RENESAS TECHNICAL UPDATE

Product Category	MPU/MCU		Document No.	TN-RX*-A164B/E	Rev.	2.00
Title	Errata to RX65N Group, RX651 Group User's Manual: Hardware		Information Category	Technical Notification		
Applicable Product	RX65N Group, RX651 Group		Lot No.	Reference Document	RX65N Group, RX651 Group User's Manual: Hardware Rev.1.00 (R01UH0590EJ0100)	
			All

This document describes corrections, as shown below, to the RX65N Group, RX651 Group User's Manual: Hardware, Rev.1.00.

Figure 51.4 Example When the 12-Bit D/A Converter Cannot Capture the 12-Bit A/D Converter Synchronous D/A Conversion Enable Input Signal

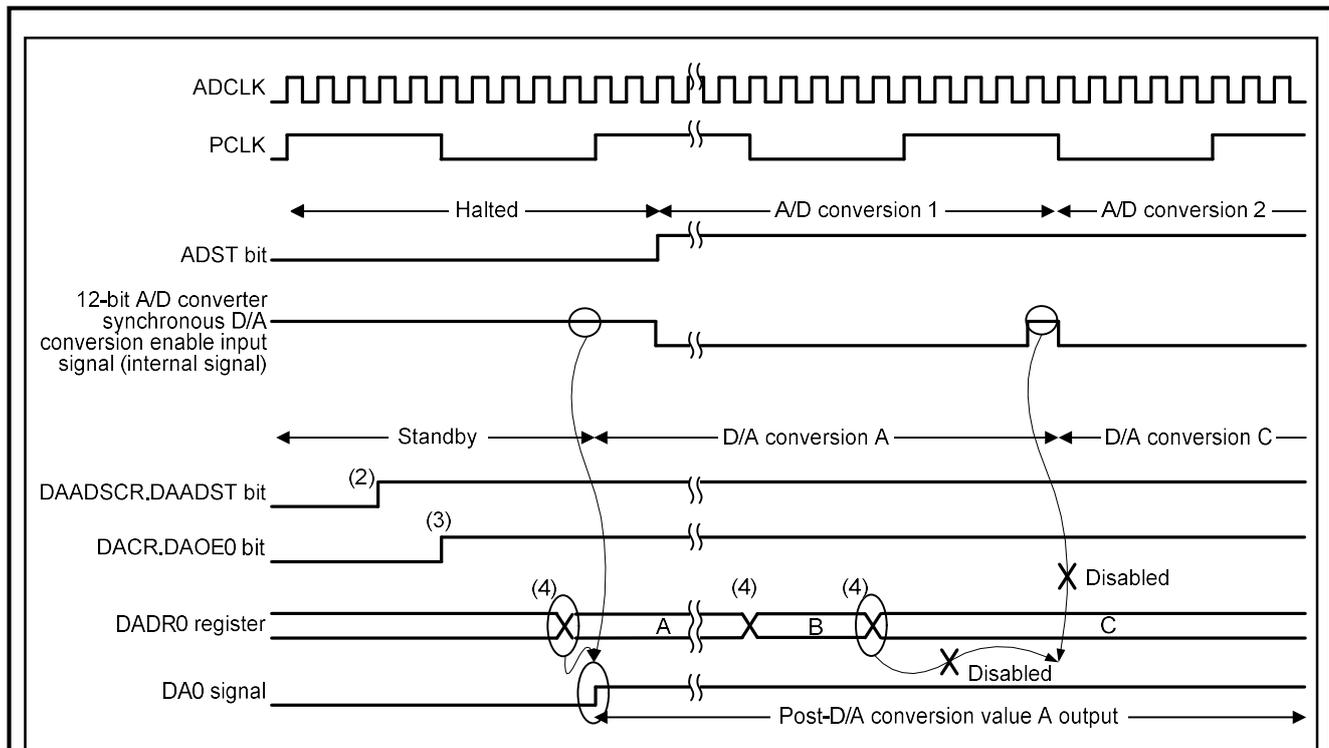
The following description and Figure 51.4 in section 51.3.1 are deleted:

When ADCLK is faster than PCLK, the 12-bit D/A converter may not be able to capture a 12-bit A/D converter synchronous D/A conversion enable input signal for one ADCLK cycle which is output between A/D conversion 1 and A/D conversion 2.

Figure 51.4 shows example when the 12-bit D/A converter cannot capture the 12-bit A/D converter synchronous D/A conversion enable input signal. In this case, post-D/A conversion value A is continuously output as the DA0 signal.
